Technical Document 105

AN/PRC-56 HELMET RADIO SET UPGRADING

Recommended modifications require minimal resources but promise considerable improvement in reliability, operability, and logistics support

Field Change (1)—AN/PRC-56 Radio Set
Operational and Reliability Improvements; Type II, Class A
Routine Action: 1.5 Man-hours/Radio

Figure 2. The old and new push-to-talk switches. Notice that the new switch is relocated and that the switchguard has been removed. The hole resulting from the switch relocation has been filled with epoxy.

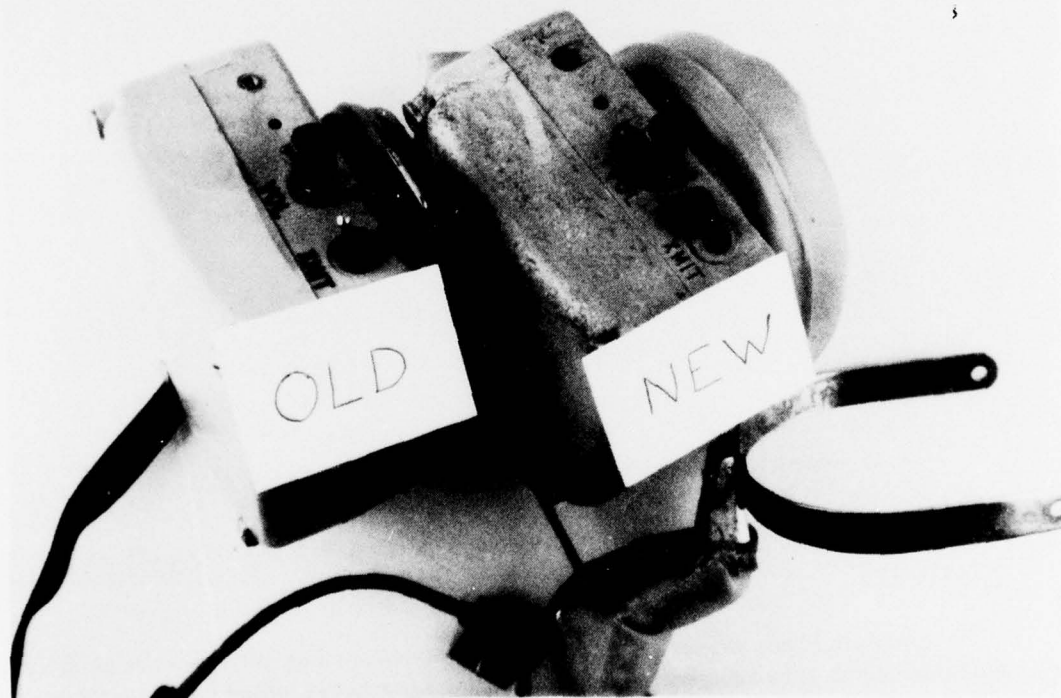
the normally open contacts. The best mechanical solution to the push-to-talk switch problem is to replace the existing toggle switch with a pushbutton switch. Miniature pushbutton switches with the rugged characteristics needed are readily available; two MIL-SPEC types were identified – M8805/64 and M8805/96. Both the M8805 switches are spst rather than spdt; however, this is a reconcilable difficulty. Also, although there is space for the switches, the mounting hole must be relocated slightly to fit them into the case. To resolve the spst/spdt difference, the receiver section was wired on, bypassing the push-to-talk switch, and worst-case tests (transmitter and receiver on the same frequency) were conducted to measure circuit stresses and to ensure no reliability problems would be introduced. This same fix was suggested independently as a solution to the problem of lack of sidetone (problem 11), since it allows the speaker to hear himself through the base station retransmission. Both the M8805 styles are satisfactory in fit and function. The M8805/96 has a more positive action and requires less force to operate, but the M8805/64 has a shorter plunger travel, which is compatible with a M5473/10-01 boot seal. Also, the M8805/64 is somewhat less expensive and easier to install; therefore, it is recommended as the replacement push-to-talk switch (fig 2).

17. Install the pushbutton switch M8805/64 with the M5423/10-01 boot. Solder the blue and white wire (from terminal 4 of TB1) to the bottom terminal of the switch. Solder the two wires which were lightly twisted together in step 4 (brown and white from E6 on the receiver; green and white from terminal S of TB1) to the top terminal of the switch. Note that the receiver will now remain on when the push-to-talk switch is activated.

Figure 3. The old and new on/off switches. Notice also the alternate foam-filled ear cushion.

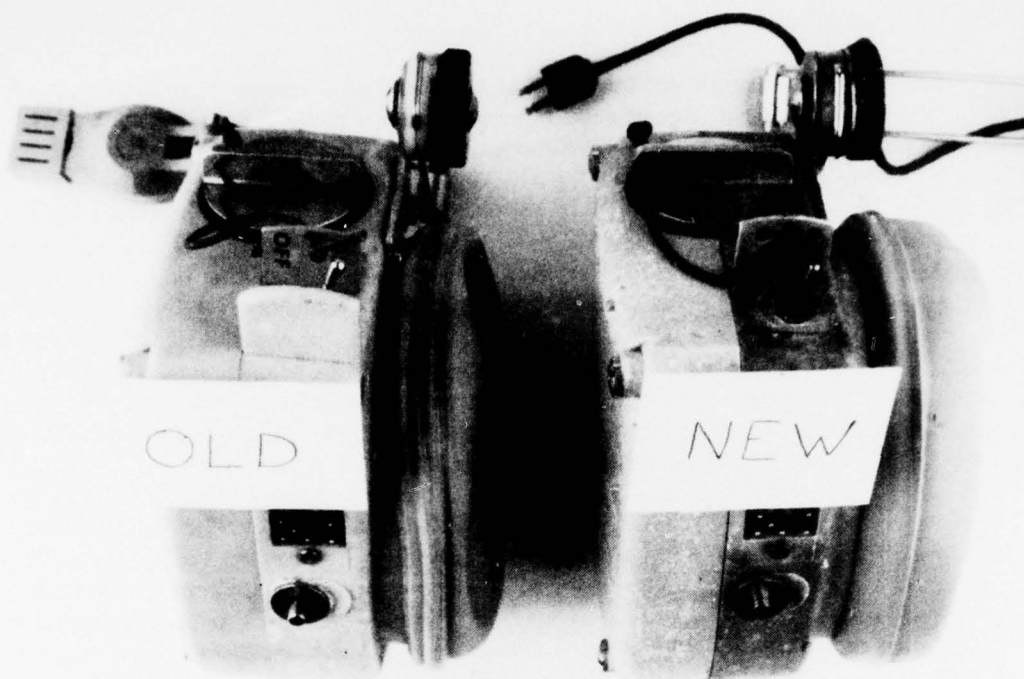
The on/off switch (fig 3) presents a different problem. The switch should provide a visual indication of its position in addition to being more rugged and dependable. Three types of switch were considered – toggle, slide, and rotary. No slide switches were found which

Of these alternatives, the ALCO switch requires the least case modification; but while this switch is mechanically more rugged, its electrical contacts are only slightly more reliable than those of the existing switch. The CSI switch and the MIL-SPEC switches are all significantly more reliable and dependable than either the ALCO or the current switches; however, they are all sufficiently long to be subject to interference from the RFI filter board in the transmitter pod. If any of these latter three switches are used, the RFI filter assembly should be moved approximately 1/8 inch (3 mm) up in the pod. The other case modifications to the PRC-56 involve removing a block of excess plastic from the inside of the case next to the mounting hole and removing the outer switchguard. The MS24655-241 is the recommended replacement.

8. Install the toggle switch (MS 24655-241) with the terminals toward the outside of the pod (away from the ear defender side), using the switch boot from the old switch. It will probably be necessary to file the plastic block in the corner of the pod back to make space for the switch; a sharp knife will assist in cutting away excess material. The "on" position of the switch should correspond to the "on" mark on the inside switch protection tab. Solder the wires removed from the old switch to the new switch; the wire from the battery (red and white) should be connected to the top terminal.

Figure 4. The old and new microphones, boom assemblies, and connecting cords. The new boom assembly has a longer foreboom. The connecting cord is wrapped around the boom to avoid snagging and to provide strain relief.

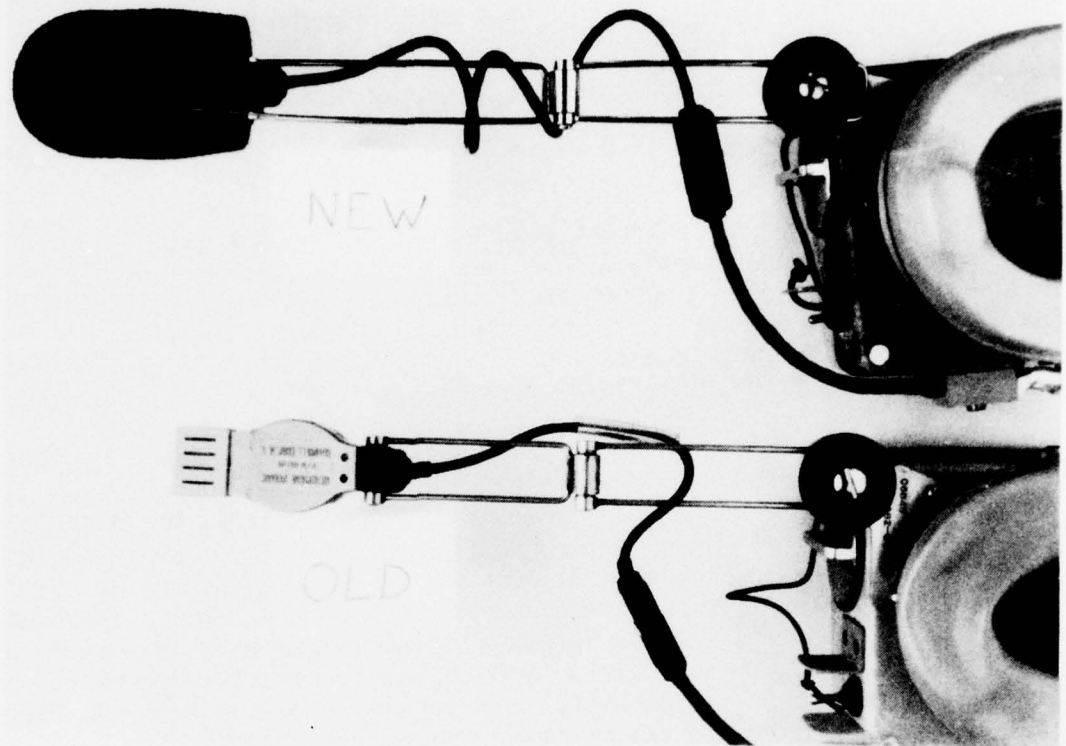
The M-87 microphone, microphone cord, and mike boom collectively suffer a very high failure rate. Failures in the microphone are both electrical and mechanical. The electrical failures appear to be caused by humidity admitted through either cracks in the case or leaks around the element seal. The cracks in the case are simply incomplete mechanical failures. A leaky element seal is most probably caused by the tearing or loosening of the seal by wind pressure. In fact, the M-87 is susceptible to saturation by wind; in the saturated condition, the output drops by at least 50 percent and the noise-canceling characteristic virtually disappears (problem 2). Another possible type of electrical failure derives from shorts or insulation breakdown, or, in conjunction with other failures, welding of the dynamic windings due to intense electromagnetic fields encountered on the flight deck (up to 200 V/m); however, there are no data confirming or refuting these failure modes. In any case, the primary electrical failure mode is humidity entering through a leaky element seal. The mechanical failures are mostly cracked cases resulting from rough abuse. The mike boom is a two-piece wire loop assembly. The most frequent failures occur at a weld on the hinge between the two pieces or at one of the wire loops. Virtually all the documented failures resulted from users' attempting to bend the mike boom to place the microphone closer to the mouth. The foreboom (the loop connecting to the microphone) is not long enough to fit all users comfortably (see fig 4). The failures to the microphone cord were breaks in the wires at the connectors (usually at the microphone end), primarily in the cloth-covered versions (as opposed to rubber or plastic coated). There are some false replacements of the microphone and cord due to input transformer failures, but these probably constitute about 12 percent of the total replacements. Research revealed a microphone assembly in the National Stock System which is made up of the M-87 with a windscreen, a mike boom with a longer foreboom, and a rubber coated cord; the stock number is 5965-00-181-0213. The windscreen will protect the M-87 from wind saturation, the element seal from wind tearing, and the case from much of the normal abuse. Additionally, the windscreen reduces annoying speech artifacts from "p" and "s" sounds and helps the user to properly position the microphone for maximum output and intelligibility.

9. Remove the microphone M-87, microphone cable (W3002), and mike boom by removing the bolt holding the boom swivel to the mounting plate.
10. Install the microphone with windscreen, boom, and cord assembly (item 1). Wrap the cord assembly around the boom 2½ times before plugging it into W3001.

Figure 5. Application of adhesive sealant.

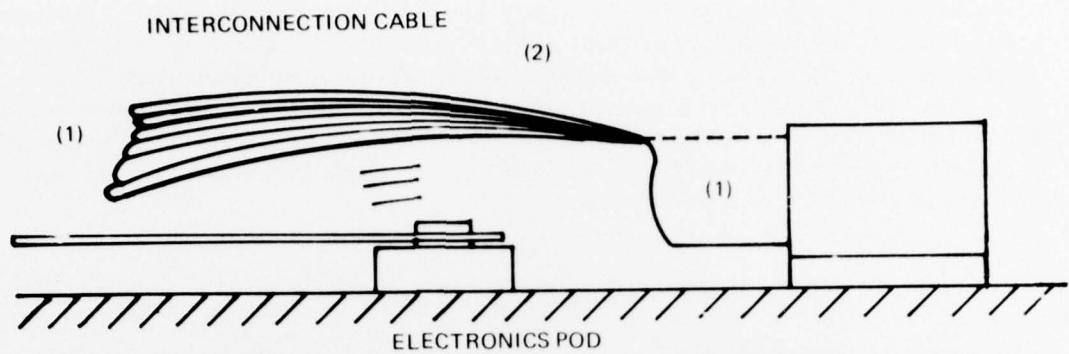
The printed circuit boards used in the PRC-56 have been shown to expand. The expansion loosens the feed-through grounds and causes intermittent contacts. Although ground connection is not lost, the intermittent contacts can detune the radio by altering the pattern of ground currents. Apparently the board expansion is caused by (1) the absorption of moisture, (2) the absorption of glycerine, and (3) aging. The board material is not particularly susceptible to moisture absorption when it is conformal coated, but frequent stripping of the coating for repairs and occasional omission of coating after repairs does contribute to the board swelling. Glycerine has been found inside a number of the pod assemblies and has been shown to contribute significantly to board swelling. The ear seals are the source of the glycerine.

- (1) FILL WITH RTV-102 (ADHESIVE SEALANT); DRY 24 HOURS (MIN) [1 WEEK PREFERRED]
 (2) COAT WITH RTV-102 FOR ABOUT 1 INCH (25mm) LENGTH INCLUDING PART OF THE CABLE TWIST

24. Ensure that the cable and connector are clean and dry. Apply RTV-102 to fill the gap between the cable and connector in accordance with the directions on the tube. Allow to cure at least 24 hours.
25. Reinstall the radio in the helmet assembly.

Figure 6. RTV-102 applied to a connecting cable to provide strain relief. Notice how the cable is held away from the pivot on the earpod.

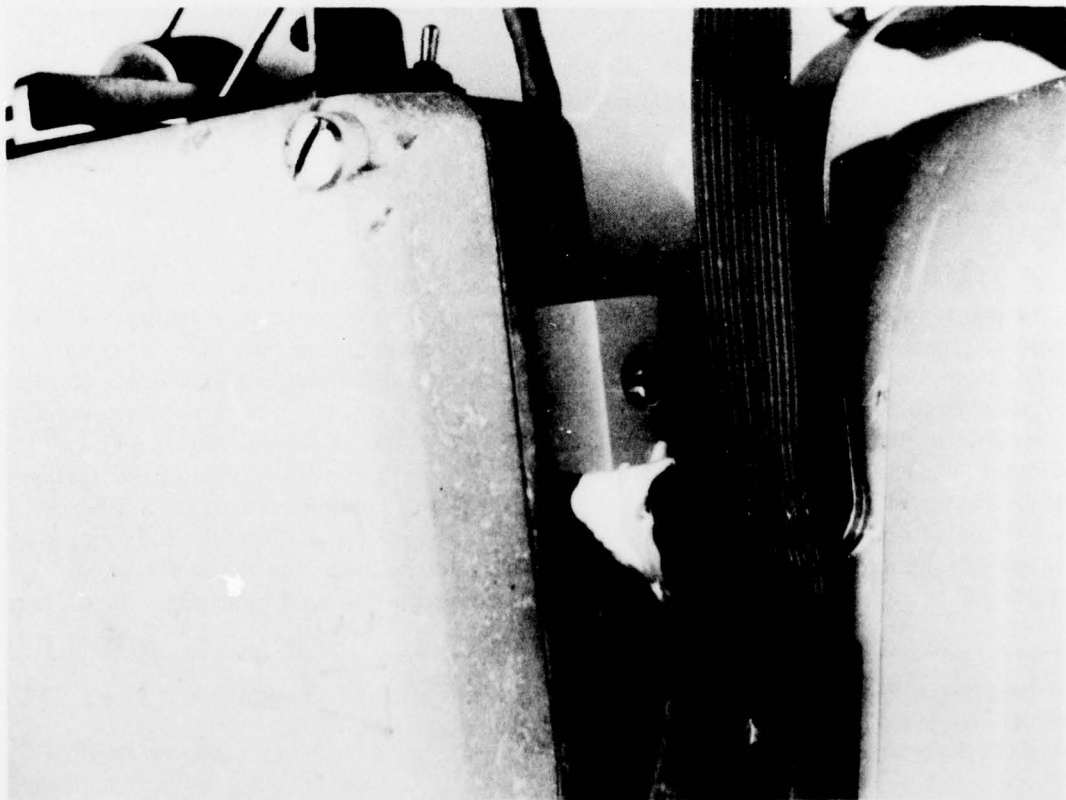
The cable assembly between the electronics pods has a moderately high failure rate. Many of the failures occur in the ribbon cable where it enters the connector blocks. At this point, the cable is flexed across its width rather than in line; this puts a severe fatiguing strain on the cable. In order to relieve the strain, it is recommended that adhesive sealant RTV-102 be applied in accordance with figure 5 or 6. Although other failures occur within the connector blocks, the design precludes doing anything to correct this problem.

23. Lay the radio so that W3001 is on top and form the cable near each connector so that the cable is above the top of the connector and forms a 1/4 inch gap between the cable loop and the connector.

Figure 8. Tape wrapped tightly around the core of a variable inductor keeps the core from vibrating out of adjustment.

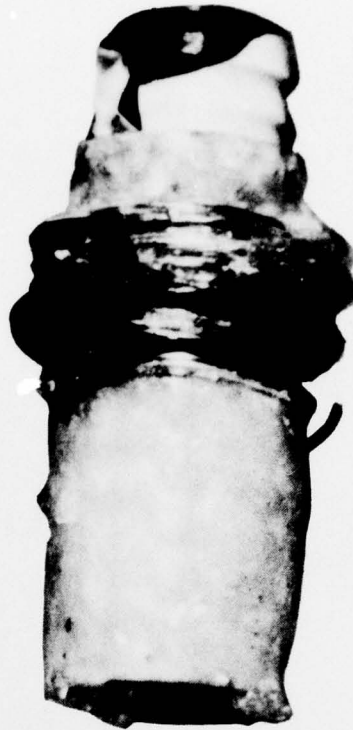
The PRC-56 is very susceptible to impact shocks and acoustic vibrations, especially in transmitter and receiver alignments. Fully 20 percent of all reported total failures (ref 4) are misalignments only and do not require a part replacement. Temporary losses of signal in certain deck locations also result from misalignments. Transmitter alignment requires 18 steps and receiver alignment requires 48 (ref 5). Considering both setting up to test and reassembling the radio, the alignment procedures require skilled maintenance manpower (often a Petty Officer First Class). A few of the adjustments are somewhat critical, but most of the misalignments are caused by the mechanical instability of the tuning components, especially the variable inductors. It is recommended that Teflon tape be used to stabilize the tuning slugs of the variable inductors. The tape will allow adjustments to be made, but the impact shock effects will become minimal. Figure 8 illustrates tape wrapped around a variable inductor core.

- a). Remove the tuning slug (count the turns required to back out the tuning slug to expedite returning).
- b). Cut a strip of Teflon tape 1/8 inch wide by the width of the tape.
- c). Wrap the tape tightly onto the tuning slug in a spiral in the same direction as the threads. Do not wrap the tape over itself. The tape should be stretched to conform to the slug.
- d). Replace the tuning slug.
